January 25, 2006
L-06-003

**Subject: Beaver Valley Power Station, Unit Nos. 1 and 2
BV-1 Docket No. 50-334, License No. DPR-66
BV-2 Docket No. 50-412, License No. NPF-73
Additional Information in Support of License Amendment Request
Nos. 302 and 173 (Unit No. 1 TAC No. MC4645/Unit No. 2 TAC
No. MC4646)**

PRA – Human Reliability and Containment Overpressure

Containment Overpressure Required and Available
CASE 4L DEHL Max SFGDs

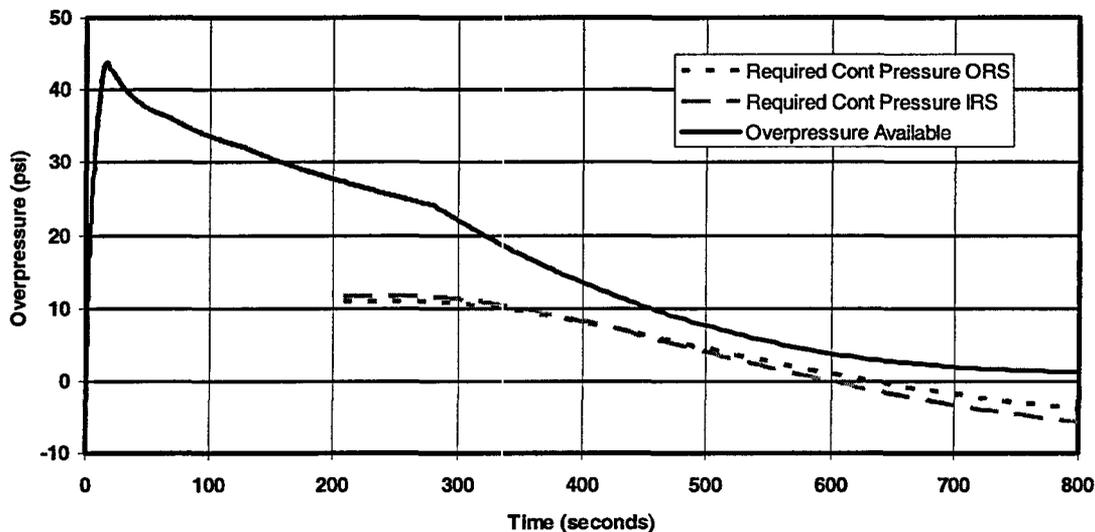
3. What is the current and the requested values of available NPSH for all ECCS and containment heat removal pumps? Provide these values as a function of time and show the amount of time that containment accident pressure is credited for available NPSH. Compare these available NPSH values with the pre-EPU values for both magnitude and duration.

The following plot shows the Containment Overpressure (COP) required for the Inside Recirculation Spray (IRS) pumps and the Outside Recirculation Spray (ORS) pumps, and the available overpressure for this case. The function of the Recirculation Spray (RS) system at Beaver Valley Power Station Unit No. 1 (BVPS-1) is to assist the Quench Spray system in reducing containment pressure following a LOCA and provide containment heat removal. The system consists of two IRS pumps and two ORS pumps which take suction from the containment sump and deliver flow to containment spray headers. The pumps start on a fixed time delay following a high containment pressure signal. Each flow path contains a heat exchanger cooled by service water which provides the only means of containment heat removal for long term cooling of the containment sump water.

The term "COP Required" has been calculated as that amount of pressure above the initial pressure in containment at the start of the accident necessary to ensure that available NPSH equals required NPSH. For this case the initial pressure is 12.8 psia which is the minimum Technical Specification value following implementation of containment conversion.

Figure 1 RCS and Steam Generator Pressures for BVPS-1 SBO11

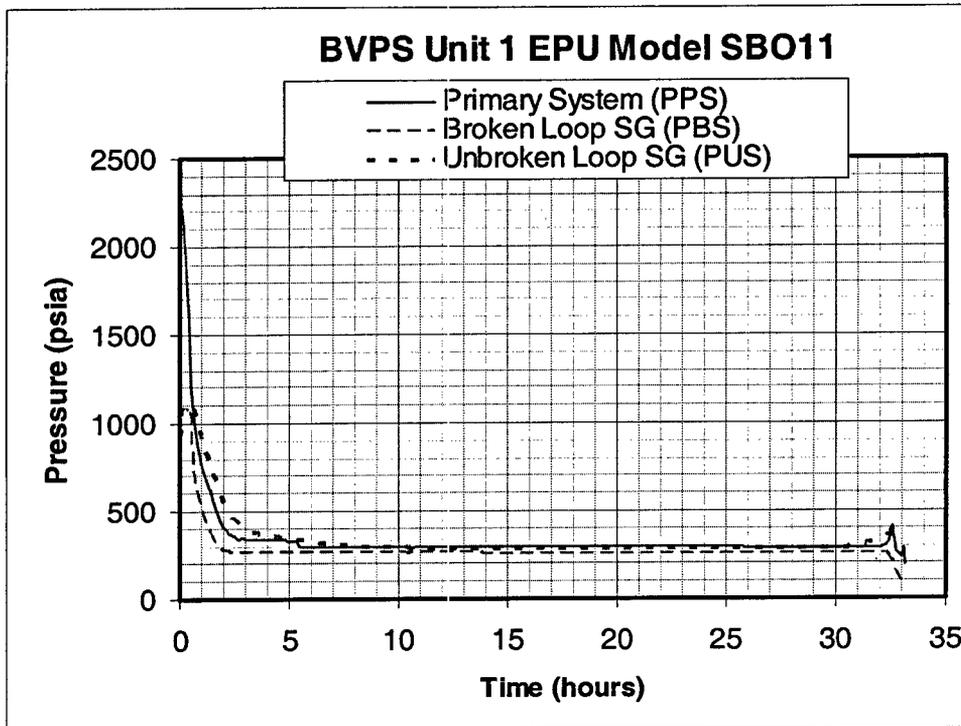
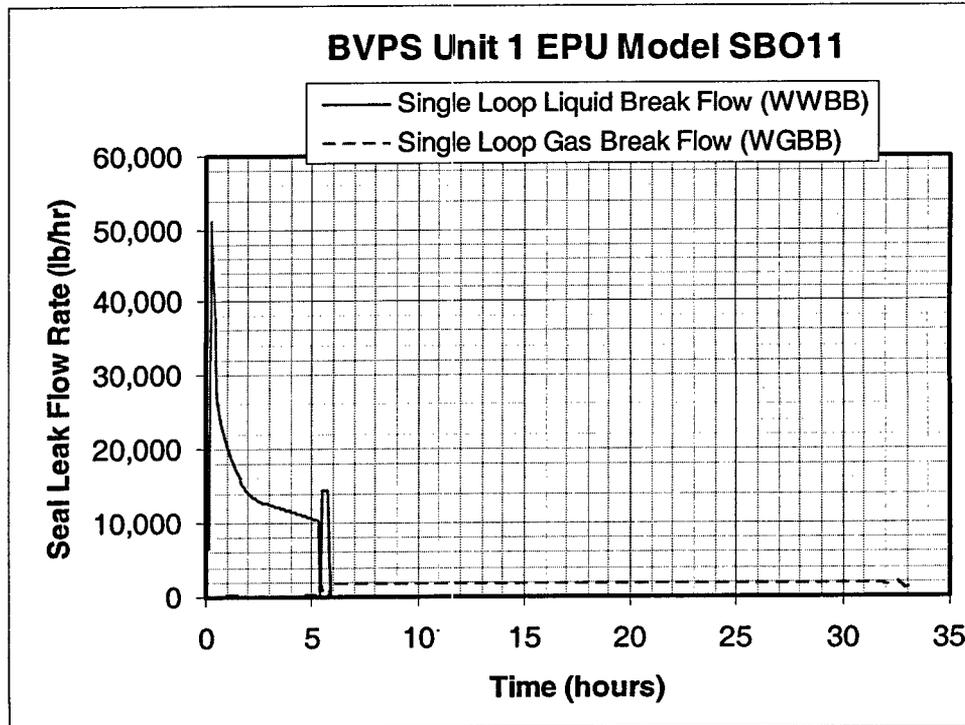
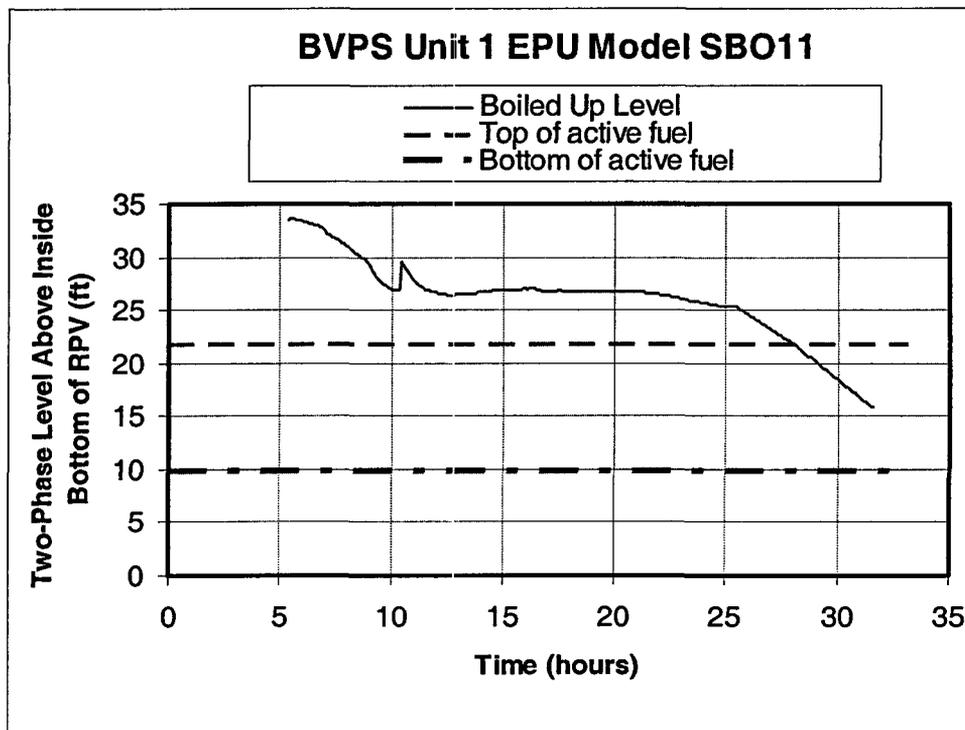
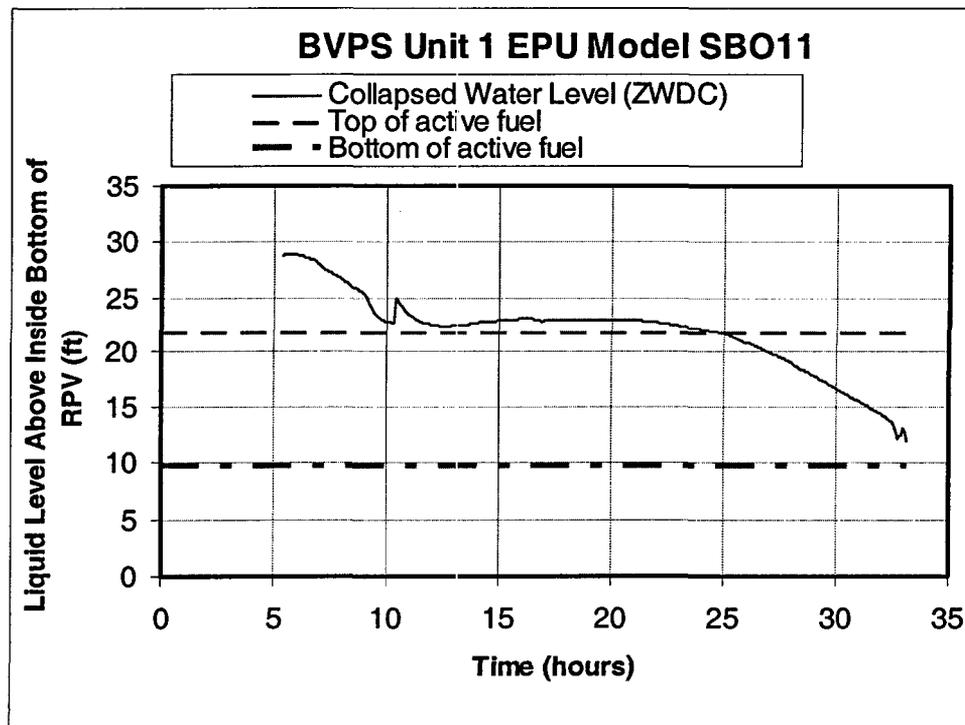
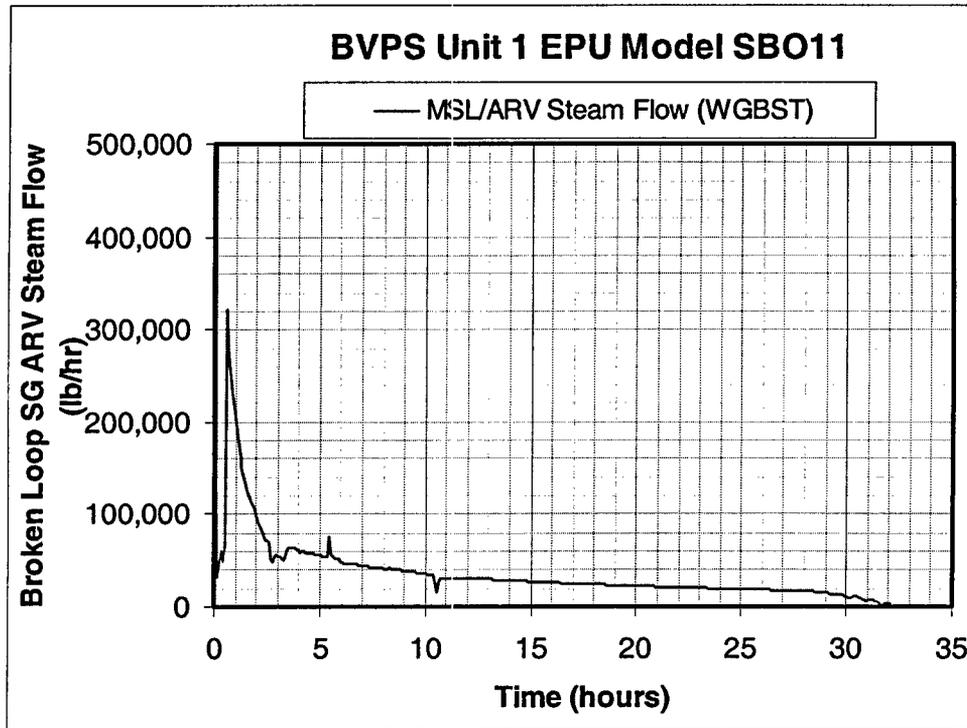
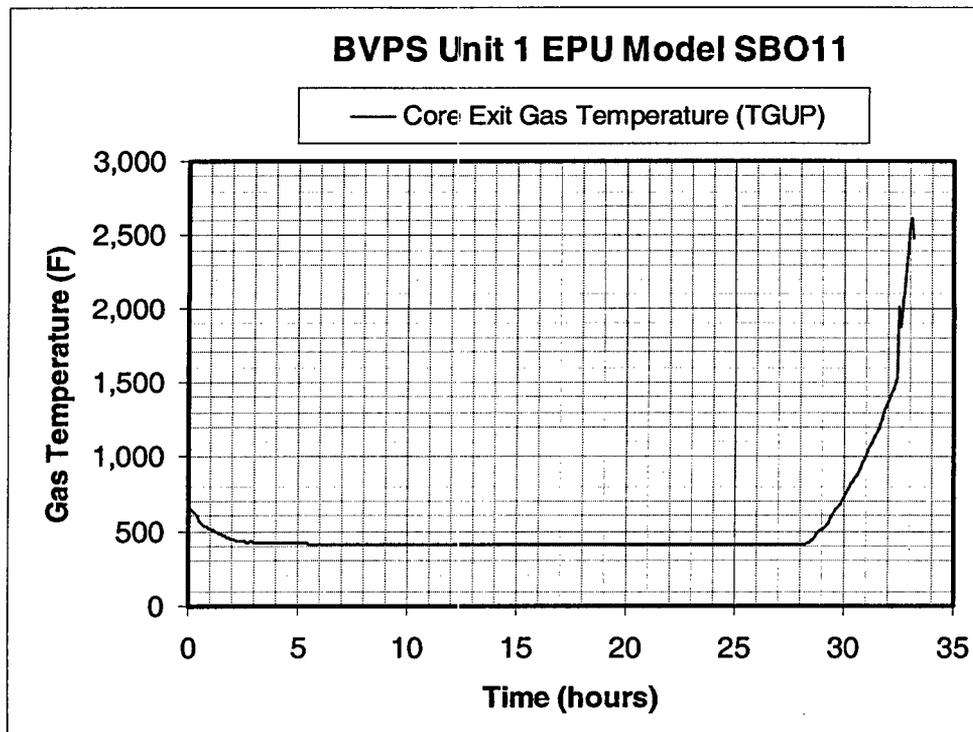
a. Please provide graphs of the following parameters as a function of time:

- RCS pressure (cold leg)
- break mass flow rate
- two-phase level in the inner vessel (show the top and bottom elevation of the core)
- liquid level in the inner vessel
- secondary pressure vs time
- secondary ADV/PORV mass flow rate
- core exit steam temperature
- core normalized power

Additional graphical information regarding the SBO11 sequence and a similar sequence without depressurization (SBO13) is provided in Attachment A “Graphical Information for BVPS-1 Sequences SBO11 and SBO13” of this enclosure. A brief discussion of this additional graphical information follows.

Figure 8 Pressurizer Level for BVPS-1 SBO11

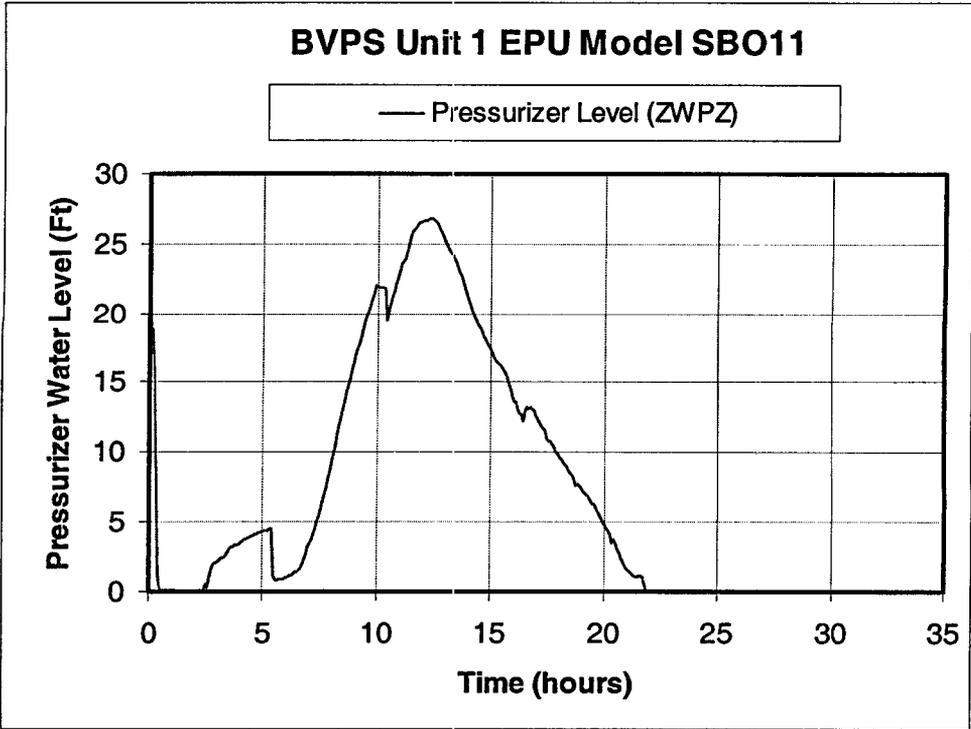
Further clarification is needed to understand the results presented. For example, the Unit 1 pressurizer level increases from 9 hours to 17 hours post-EPU, but the accumulators appear to have finished injecting before 3 hours. As another example, the Unit 2 analysis shows a slightly shorter time to core damage post-EPU, whereas Unit 1 shows an increase. In order for the staff to determine whether this behavior is real or an attribute of the modeling, additional information is needed.

Further clarification is being provided for the results presented in the FENOC Letter L-05-192 (Reference 1) for the response to RAI Question 2.c for the BVPS-1 pressurizer level increase from 9 to 17 hours for sequence SBO11 and the increase in the post-EPU core damage time.

In the BVPS PRA analyses, a number of station blackout (SBO) accident sequences are investigated. One of these (SBO11) considers a station blackout with auxiliary feedwater being available for an extended interval (approximately 24 hours) with the secondary side depressurized. After approximately 4.5 hours, the RCS is depressurized to approximately 300 psia and is held at this pressure for the next 25 hours. During the first 4.5 hours, accumulator injection refills the pressurizer to a level of approximately 4.5 feet. There is an injection from the accumulators just after 5 hours and this cold water initially reduces the boiled-up level in the RCS causing the pressurizer to almost empty. However, as this water temperature increases, the boiled-up level in the RCS is restored and causes the pressurizer level to increase approximately 7 feet. At approximately 6 hours, the pressurizer level increases by an additional 17 feet. The reason for this level increase has been investigated, and as discussed below, is due to the heat loss from the pressurizer to the containment when the surge line entrance is covered.

For SBO11, the Reactor Coolant System (RCS) is initially depressurized (to approximately 400 psi after 2 hours) such that there is reverse energy transfer from the pressurizer vessel wall to the lower temperature steam and water inside the pressurizer. During this interval, the pressurizer wall continues to lose energy to the containment. After approximately 5 hours, the heat loss from the pressurizer wall to the containment causes the wall temperature to decrease and eventually there is essentially no energy transfer between the pressurizer steam and water inventories and the pressurizer wall. Due to the continued heat loss to the containment, the wall temperature eventually decreases sufficiently that the energy transfer is from the steam and water to the pressurizer wall. This begins at approximately 6 hours and the average energy transfer rate from the steam region calculated by the code over the next three hours is approximately 32 kW. Meanwhile, the heat loss from the water region causes the temperature to decrease from the saturation value of approximately 432°F to approximately 408°F; i.e., the pressurizer water is subcooled. During this time, the RCS is held at essentially a constant pressure of 300 psi. A heat loss of 32 kW causes a condensation rate of 0.037 lbs/sec or a volumetric reduction rate of the steam region of 0.058 ft³/sec. This heat removal rate and condensation continues for approximately 3 hours and corresponds to a steam volume decrease and a water volume increase of 628.5 ft³, or a 14 foot increase in the pressurizer level. These calculations are close to the MAAP calculated water level increase and demonstrate that the reason for the pressurizer level to increase under these conditions is the combination of (a) the pressurizer inlet being submerged, and (b) the pressurizer volume experiencing a heat loss from the steam region to the pressurizer vessel wall and thus to the containment. Condensation of the steam causes water to be pulled from the RCS into the pressurizer. Also note that any

Eventually, the combined leakage rate from the three RCP seal LOCAs considered in this sequence results in sufficient voiding of the RCS that the surge line entrance is uncovered. When this occurs (approximately 10 hours into the sequence) the pressurizer starts to drain its inventory back into the RCS. Note that drainage does not occur at 17 hours as shown in Reference 1 but occurs at approximately 10 hours. Shortly after 10 hours, another accumulator injection occurs. This change in the on-set of pressurizer draining is due to an error in the BVPS MAAP parameter file associated with the pressurizer surge line configuration; i.e., the inclusion of a loop seal in the surge line and the assumption that the surge line enters from the top of the hot leg. The BVPS units do not have a loop seal and the surge line enters at the center line elevation of the hot leg. However, the error associated with the surge line configuration does not impact MAAP results that occur prior to the hot leg and attached surge line being uncovered, as inventory is lost from the RCS. The post-EPU pressurizer level provided for the SBO11 sequence in Reference 1 included the effect of a loop seal such that the elevated level (approximately 20 ft) was sustained until approximately 17 hours when the surge line entrance was uncovered. The revised graphical information discussed below uses the proper surge line configuration; i.e., no loop seal and the surge line enters at the centerline of the hot leg.

Figure 12: Comparison of the VFOLO Drift Flux Model and FLHT and IIST Experiments.

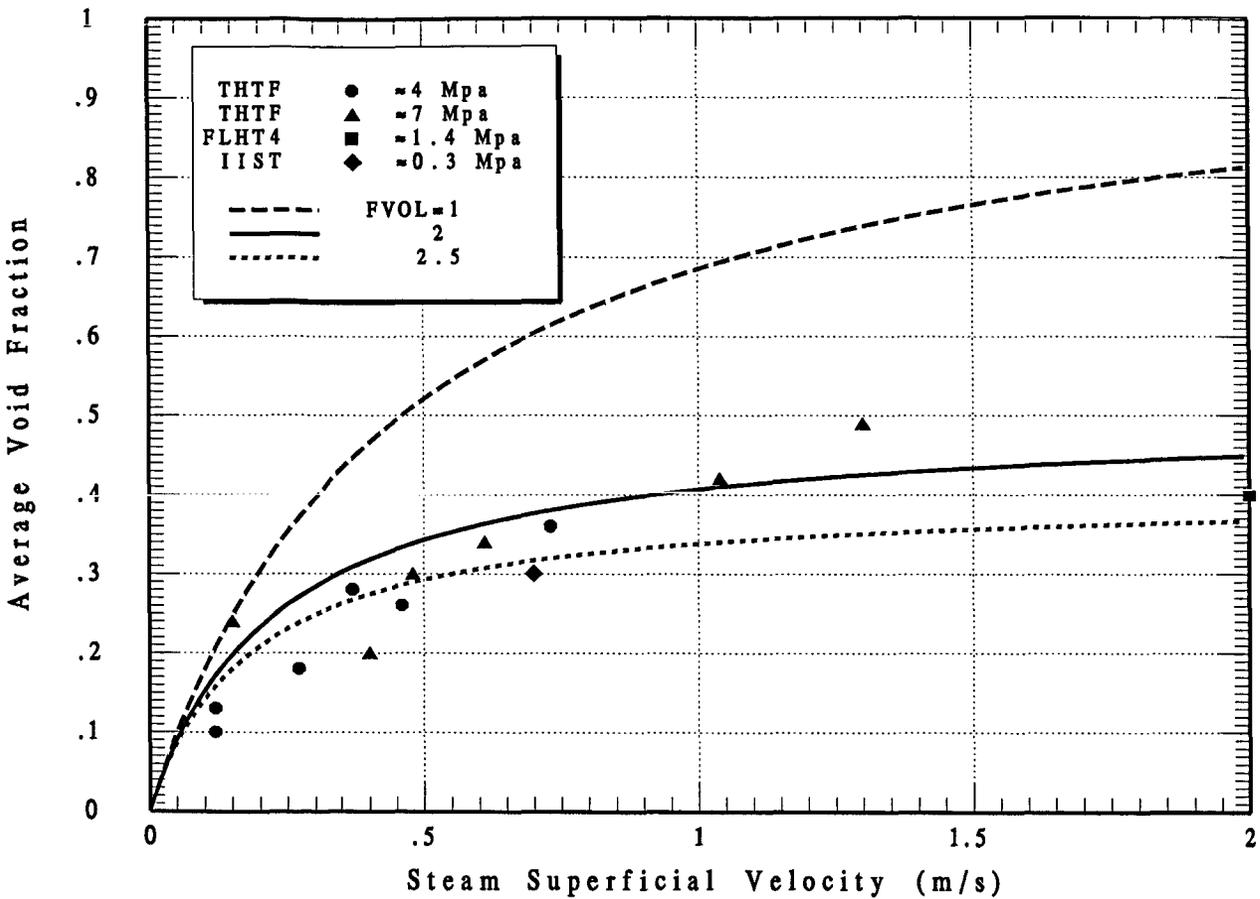
b. Please provide results of the MAAP benchmarking efforts to demonstration that MAAP can compute time to uncover for SBLOCAs. As such please provide the following benchmarks:

(1) Separate effects test comparisons to demonstrate MAAP can accurately predict two-phase level swell. Please show comparisons of MAAP to level swell tests with heat addition as well as depressurization experiments (see, for example, the THTF steady state uncover tests as well as the 336 rod bundle uncover tests in the G-2 facility, etc.).

Figure 8 shows the results for test #4 with the boiled-up level being about 3.1 m with the collapsed level at 2.25 m. Table 2 also lists the inlet water temperature at 358 K (85°C) with a system pressure of 1.4 MPa with a saturation temperature of about 473 K (200°C). Therefore, the heated length required to bring the incoming cold water to saturation is about 0.73 m. Substituting this into Equation 9 gives a value for the average void fraction of 0.4 in the saturated region. This is also in agreement with the prediction of function VFVOL for the higher superficial steam velocity of about 2 m/sec. Hence, even with the nonprototypic unheated surface area, the level swell is in agreement with the MAAP4 model as shown in Figure 12.

Reviewing Figure 11a shows that the core is one meter high and that the collapsed water level at the time that overheating occurs is approximately 0.7 m. Consequently, the average void fraction in the core region at the time that overheating occurs is 0.30%. With the power level, cross-sectional flow area and system pressure mentioned earlier, and assuming that the incoming water is saturated, the superficial steam velocity through the heated bundle is 0.69 m/sec. As illustrated in Figure 12, this point is in very good agreement with the results from the full height, full pressure THTF tests which has a similar superficial steam velocity. It is also important to note that this small scale system, has a much larger ratio of unheated to heated surface within the test bundle. As noted earlier, this tends to skew the results towards a lower average void fraction within the heated bundle. Hence, while this lies on the lower boundary considered for the uncertainty in boiled up level calculations, a large core configuration would be expected to have a higher average void fraction than is demonstrated by these scaled tests. Nonetheless, they provide a good representation of the lower bound for the boiled up pool behavior.
